Addendum No. 1
May 28, 2020

Project: Wegner Library Renovation
University of South Dakota
Sanford School of Medicine
Sioux Falls, South Dakota
OSE Project #R0620--21X
Architecture Incorporated Project #2875

Architect: Architecture Incorporated

1) DRAWING SHEET 9.20 – FIRST FLOOR PLAN – LIGHTING, POWER & SIGNAL

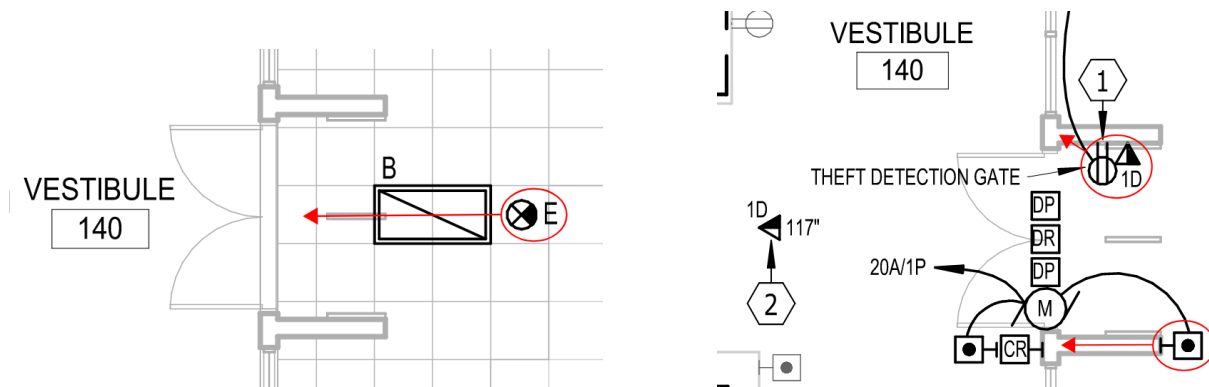
- a) In reference to the lighting and power layout, shift lighting and devices as shown below to accommodate deletion of wing walls:

about contents
FIRST & SECOND FLOOR PLAN - DEMO - VENT. & A/C

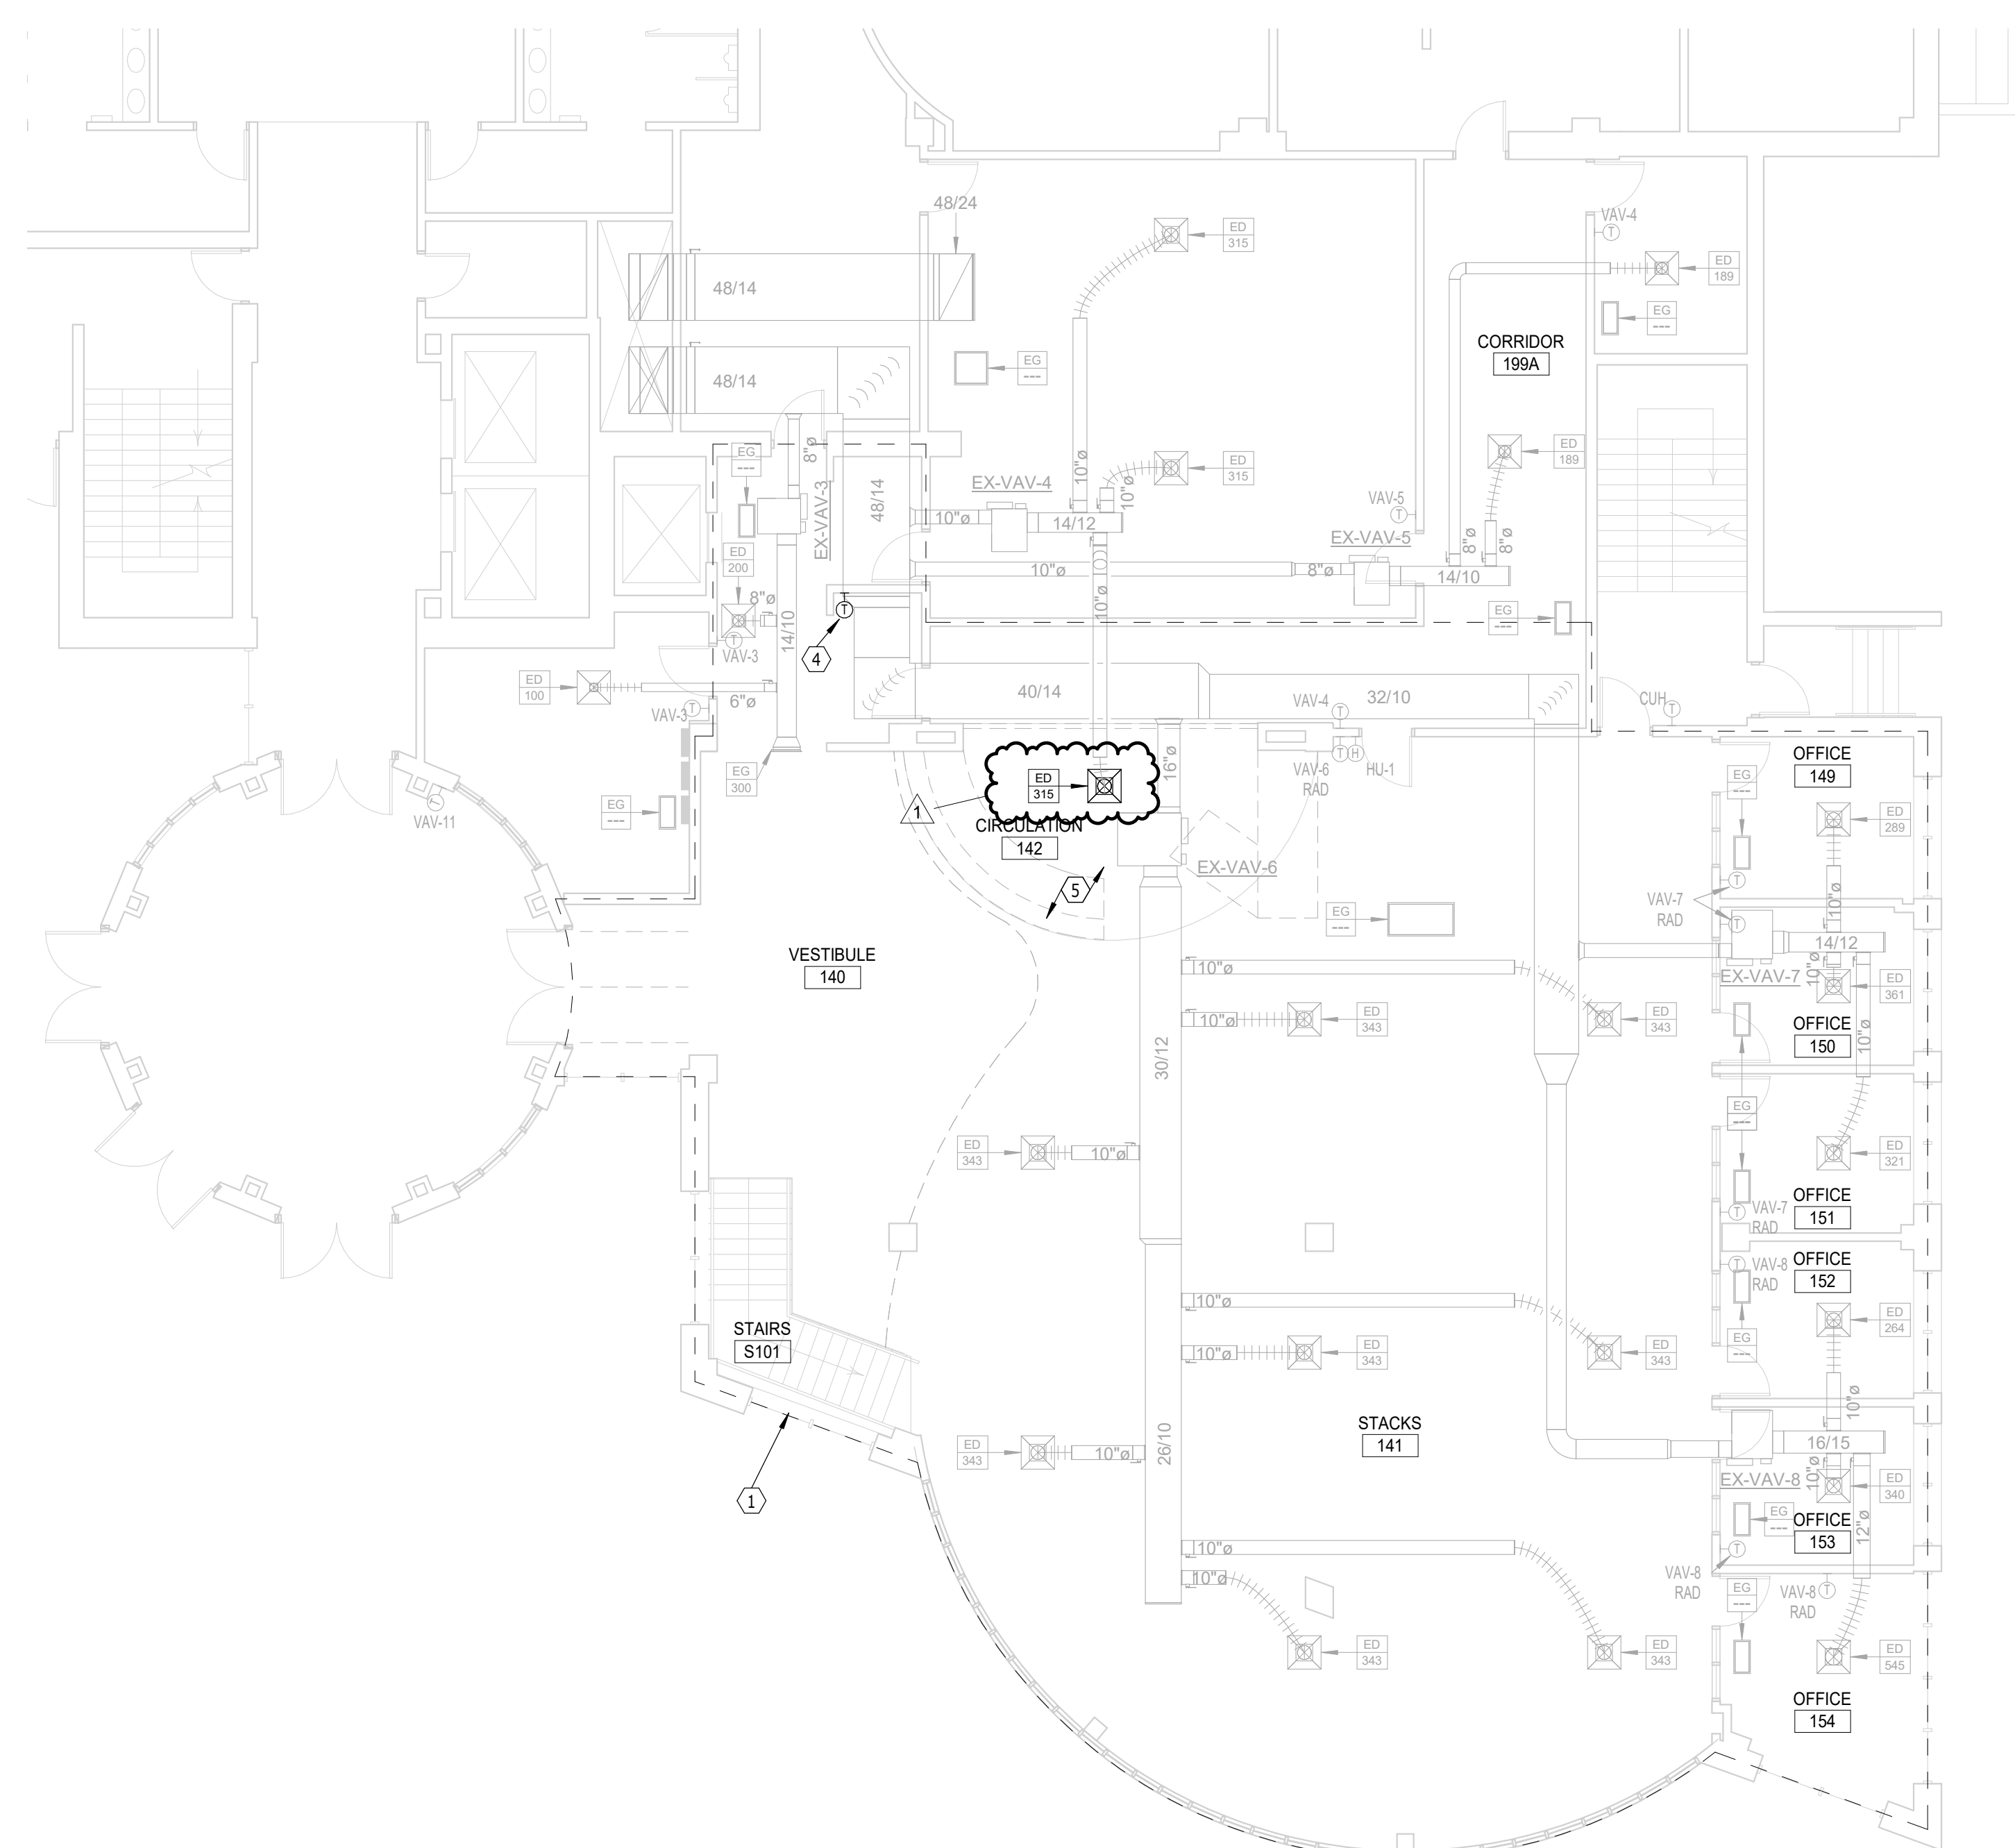
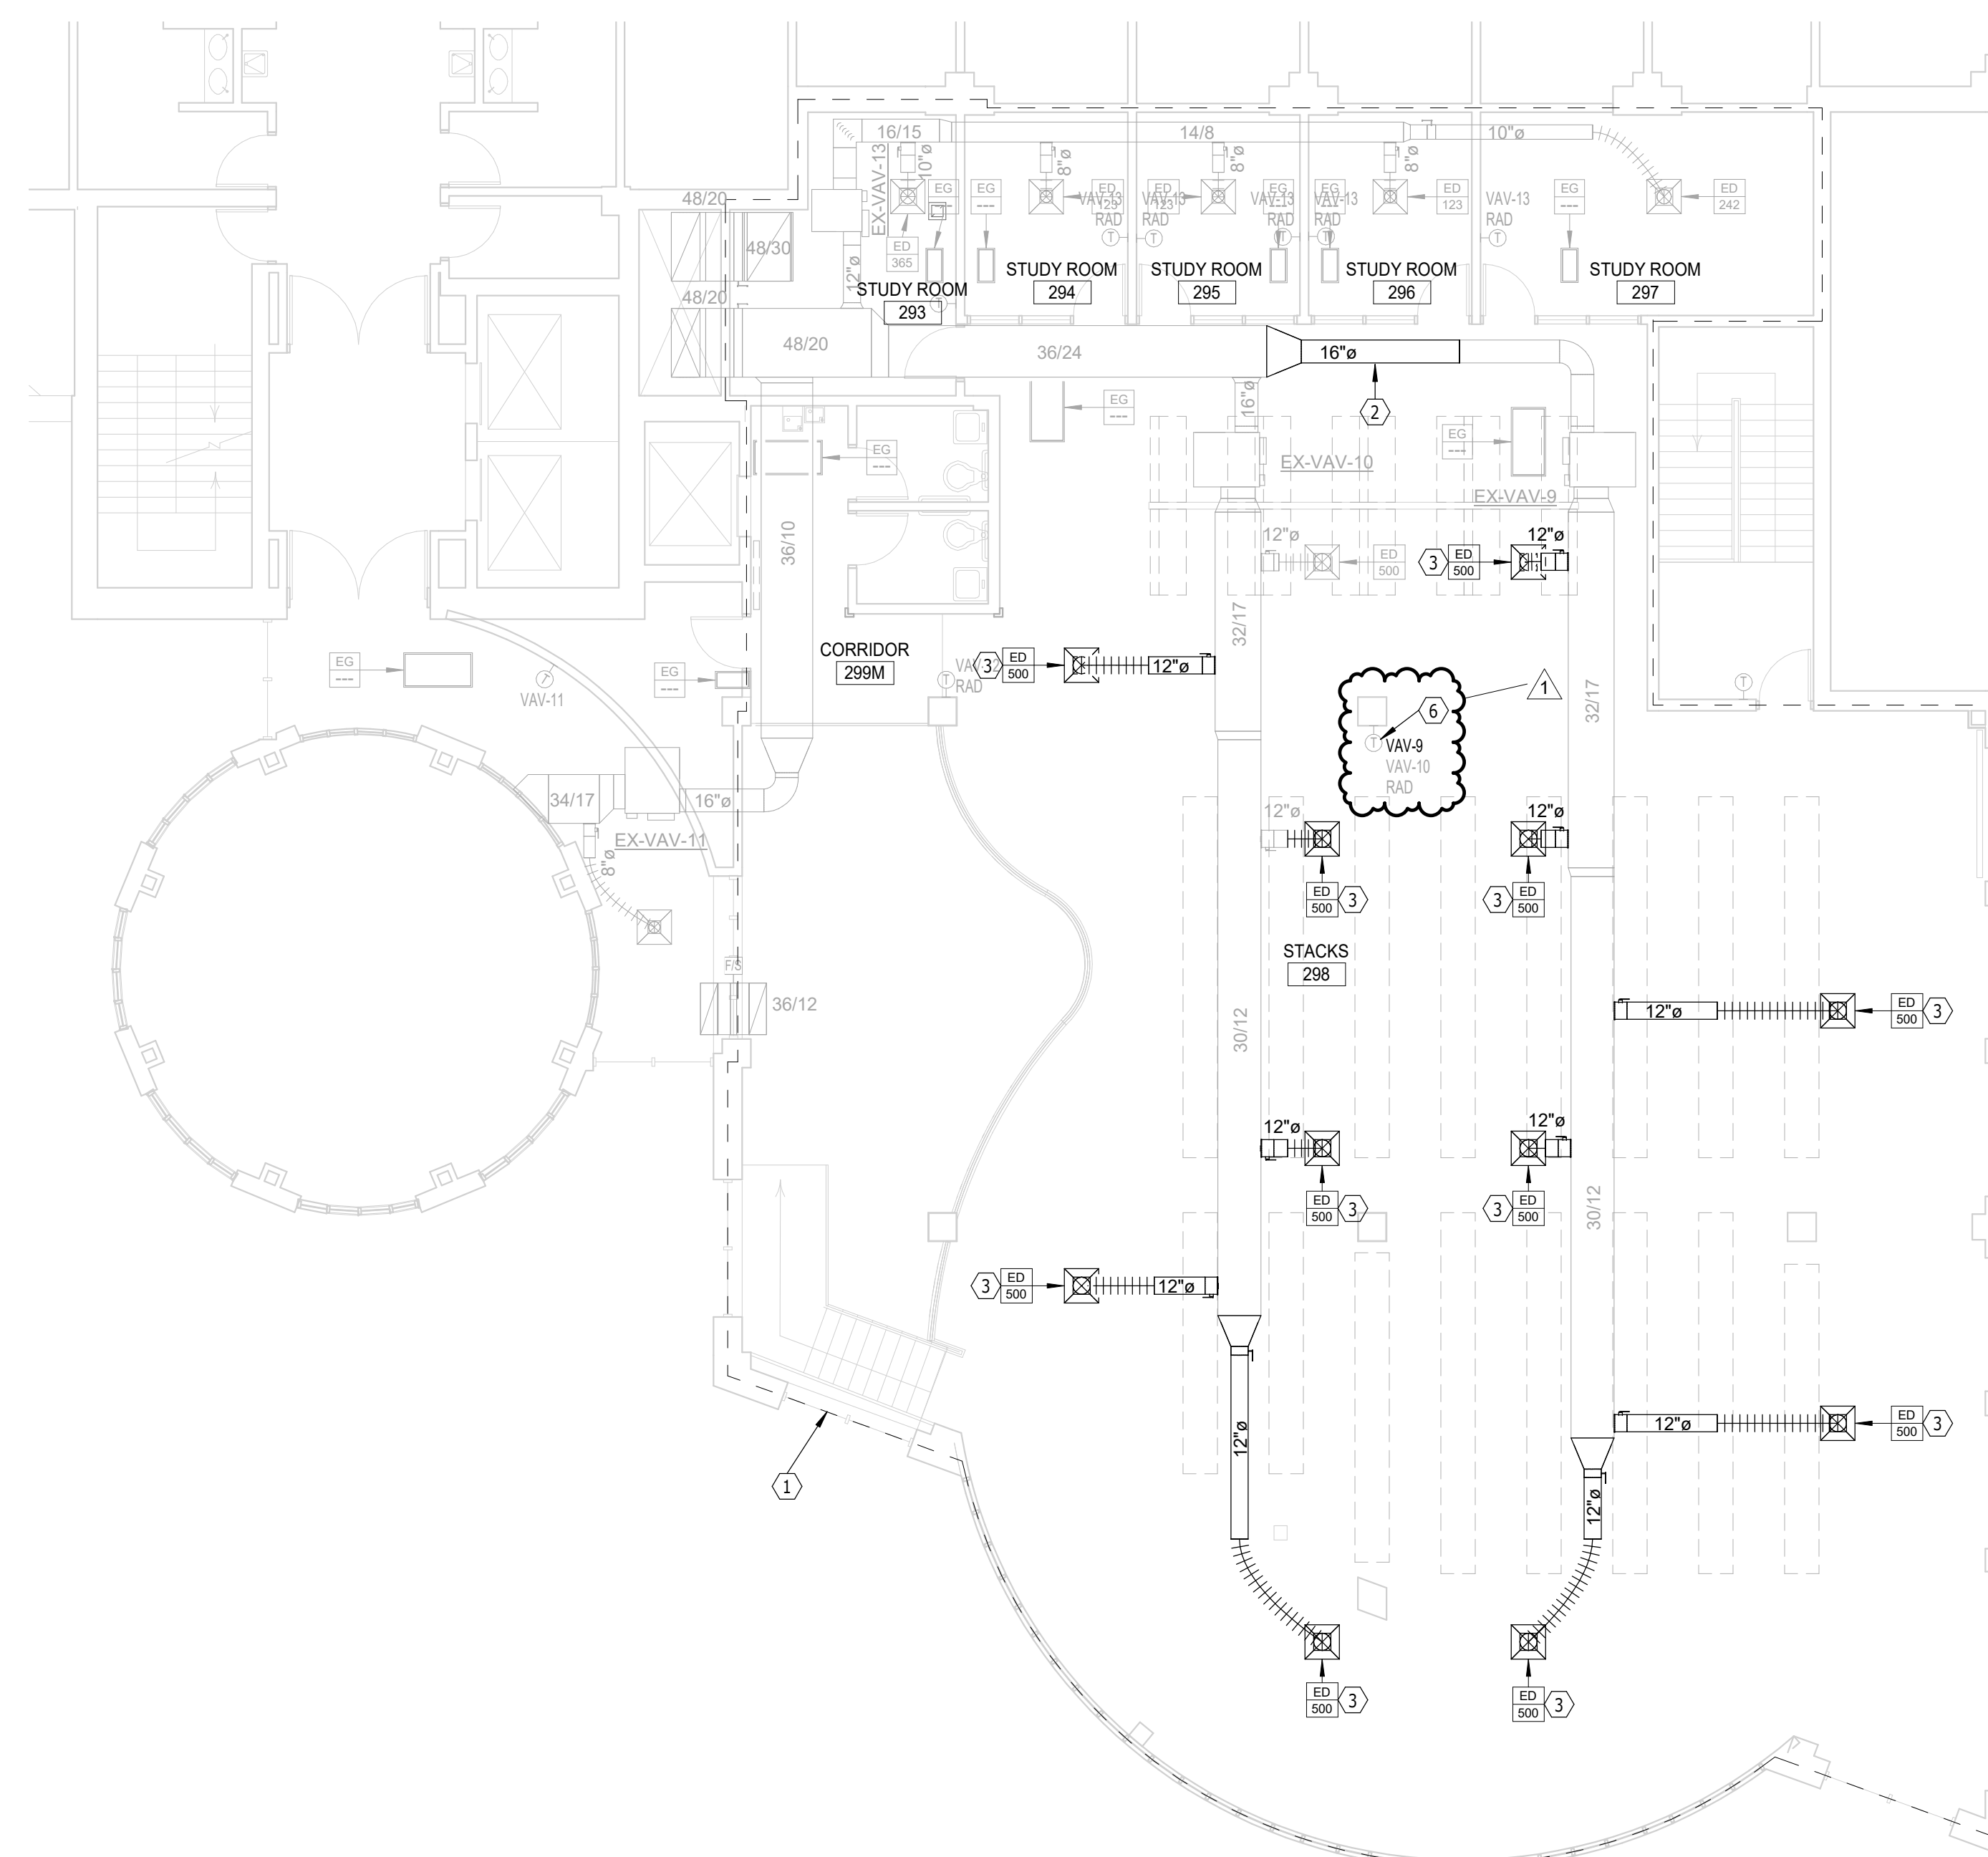
- a) Remove VAV-9 thermostat wiring from existing thermostat. Refer to attached revised drawing sheet 8.30, dated 05-28-20.
- b) Remove any grilles/diffusers as required for ceiling demolition on First Floor. Clean/repair as required for re-installation in new ceiling. Refer to attached revised drawing sheet 8.31, dated 05-28-20.

3. REMOVE DIFFUSER AND ASSOCIATED DUCTWORK BACK TO MAIN.
 4. REMOVE EXISTING THERMOSTAT. SALVAGE FOR REINSTALLATION.
 5. REMOVE ANY DIFFUSER GRILLES AS REQUIRED FOR CEILING DEMOLITION

6. DISCONNECT THERMOSTAT WIRING FOR EXISTING VAV'S TO BE CONNECTED TO NEW THERMOSTAT.
